Title: Advisory Committee on Nuclear Waste
133rd Meeting

Date: Wednesday, March 20, 2002

High-Level Waste Performance Assessment

Sensitivity Studies

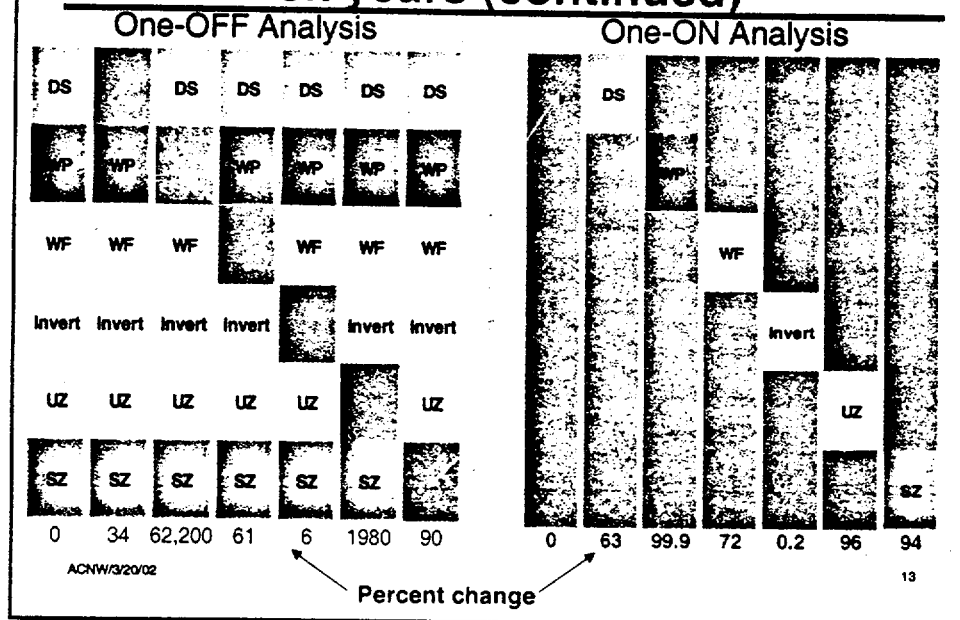
7 But on Slide 13, I'm having trouble
8 relating this to the physical world in that on the
9 one-OFF, if you remove the waste package, you have a
10 62,200 percent change.

13 On the one-OFF analysis, when you remove
14 the waste package, you have a 62,200 percent change,
15 but with the one-ON analysis, none of the other
16 barriers are there. You just add the waste package.
17 You only have 100 percent change. Factor 2. It
18 doesn't seem consistent with the physical world, as I
19 visualize it.

7 CHAIRMAN HORNBERGER: You can't take away
8 any more than 100 percent. But if you have something
9 to start with, you can change it by 62,000 percent.

13 CHAIRMAN HORNBERGER: Even with the
14 numbers, I would maintain it's very difficult to
15 figure out what the significance of what this charge
16 is.

15 CHAIRMAN HORNBERGER: I have a question
16 now that you have mentioned your one-ON analysis. If
17 we look at that lefthand column, okay, you have a dose
18 associated with that, is that right? What you said
19 was that we could read those as 99.9 percent reduction
20 in dose?

22 CHAIRMAN HORNBERGER: So my question is
23 what is the dose in that lefthand column and how did
24 you calculate it?

20 MR. MOHANTY: Let me explain the
21 difference. Under the one-OFF analysis, the first
22 column represents the nominal case. For the nominal
23 case, the peak expected dose is .021 millirems per
24 year, whereas under the one-ON analysis, we are
25 determining the percent in change based on the first

1 column under one-ON analysis. And that number, I
2 don't remember what that value is, but we are using
3 that number to determine the change. So that means at
4 most it can be that. So when we put the waste
5 package, so 99.9 percent represents a reduction in
6 what we observe under column 1.
